**SUQUEHANNA STEAM ELECTRIC STATION  
SUPPLEMENTAL RESPONSE TO REQUEST FOR  
ADDITIONAL INFORMATION REGARDING  
GENERIC LETTER 96-06 DATED JULY 26, 2001  
PLA-5400**

**Docket Nos. 50-387  
and 50-388**

## **Revised Response to NRC Question 8**

**SUQUEHANNA STEAM ELECTRIC STATION  
RESPONSE TO REQUEST FOR ADDITIONAL  
INFORMATION REGARDING SUPPLEMENTAL  
RESPONSE TO GENERIC LETTER 96-06  
DATED JULY 26, 2001  
PLA- 5352**

**Figure 1 Drywell Temperature Profiles for Small Break LOCA Accident (SBA) and Loss of Drywell Cooling (LODWC).**

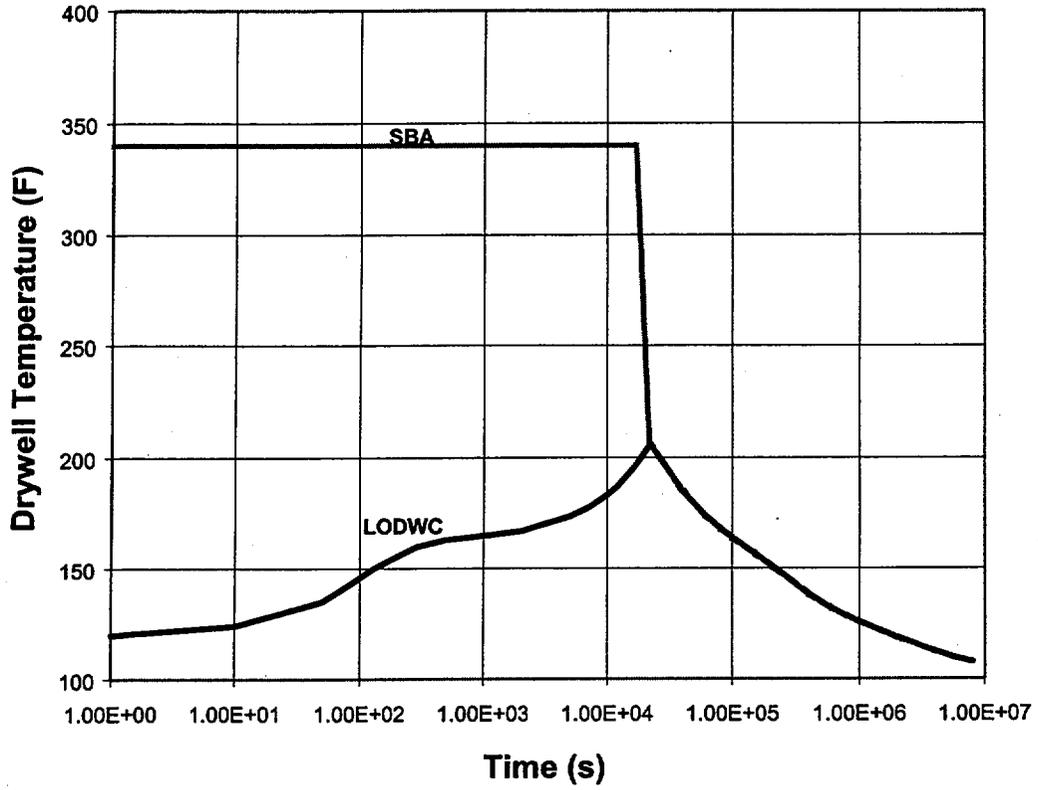
Provide further justification for P[3] - containment heating causes heating and expansion of the water trapped between the isolation valves over-pressurizing the pipe until rupture. At a minimum, please, address additional failure modes such as station blackout and human reliability.

Figure 1 shows the temperature profile associated with the small break LOCA. This temperature profile bounds all other temperature profiles including large break LOCA and Loss of Drywell Cooling. The Loss of Drywell Cooling event provides the bounding temperature for all non-LOCA MSIV closure events such as Station Blackout. The analysis results described in the responses to questions 7 and 8 show that no penetration experiences an increase in internal pressure sufficient to cause a pipe failure for the bounding small break LOCA temperature profile.

The only operator action assumed in the analysis is the initiation of shutdown cooling six hours after the small break LOCA. Emergency operating procedures direct the operators to initiate shutdown cooling. It is expected that the 98 psig interlock will clear in 3-4 hours after the event occurs. Thus the 6-hour assumption bounds the expected time for initiation of shutdown cooling. Operation of shutdown cooling prior to 6 hours will shorten the time in which the drywell is at the peak temperature shown in Figure 1.
